APPLICATION NO.	FILING DATE	FIRST NAMED INVENTOR	ATTORNEY DOCKET NO.	CONFIRMATION NO.
10/812,426	03/30/2004	Tony A. Cutshall	DEP 5069	3354
27777 7590 03/26/2010 PHILIP S. JOHNSON JOHNSON & JOHNSON ONE JOHNSON & JOHNSON PLAZA NEW BRUNSWICK, NJ 08933-7003				
EXAMINER GEORGE, TARA R				
ART UNIT 3733		PAPER NUMBER		
NOTIFICATION DATE 03/26/2010		DELIVERY MODE ELECTRONIC

### Office Action Summary

## DETAILED ACTION

FIG. 28

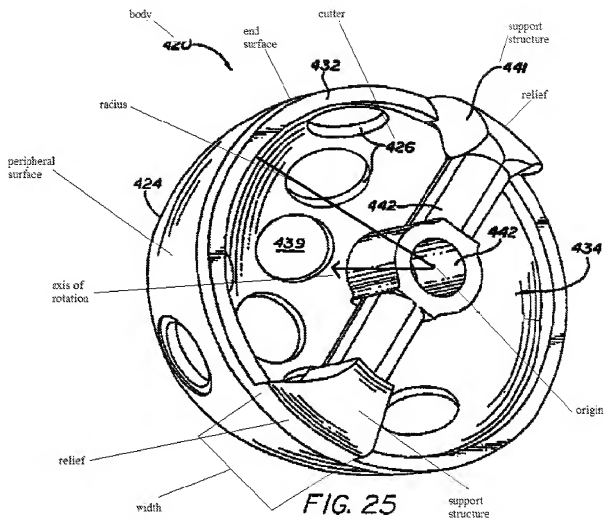
With regards to claims 9, 10, 14, 23, 26 and 33 White discloses angles between the relief surfaces as shown by figures 25, 28 and 29 but does not disclose wherein said angle can be less than 90 degrees, and the distance between the first and second relief surfaces is less than  $\frac{2}{3}$  of the radius of the body.

It would have been obvious to one having ordinary skill in the art at the time the invention was made to construct the reamer of White with the first and second relief surfaces defining an included angle therebetween, wherein said angle can be less than 90 degrees, and the distance between the first and second relief surfaces is less than  $\frac{2}{3}$  of the radius of the body, since it has been held that discovering an optimum value of a result effective variable involves only routine skill in the art. In re Boesch, 617 F.2d 272, 205 USPQ 215 (CCPA 1980).
